ERRATA

An Experimental Study of Block Shear Failure of Angles in Tension

Paper by HOWARD I. EPSTEIN
(Second Quarter 1992)

Errata by HOWARD I. EPSTEIN

Figure 1 in this paper showed, in part:

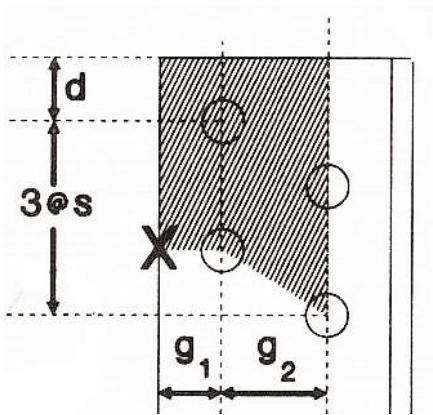
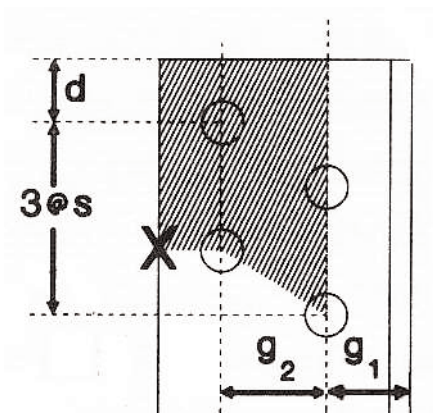
The paper states that standard gage lines were used for the angles and g_1 and g_2 are given in the paper for the 5-in. and 6-in. connected legs. This figure incorrectly showed the gages. The correct labeling should have been:

This error was brought to light by the discussion of the paper "AISC Rules for Block Shear—A Review" by Geoffrey L. Kulak and Gilbert Y. Grondin. It should be noted that the numbers shown in the 1992 paper are correct and are based on the gages shown in the corrected figure and on the governing block shear equations at the time of publication. The LRFD block shear equations have gone through two revisions since that publication.
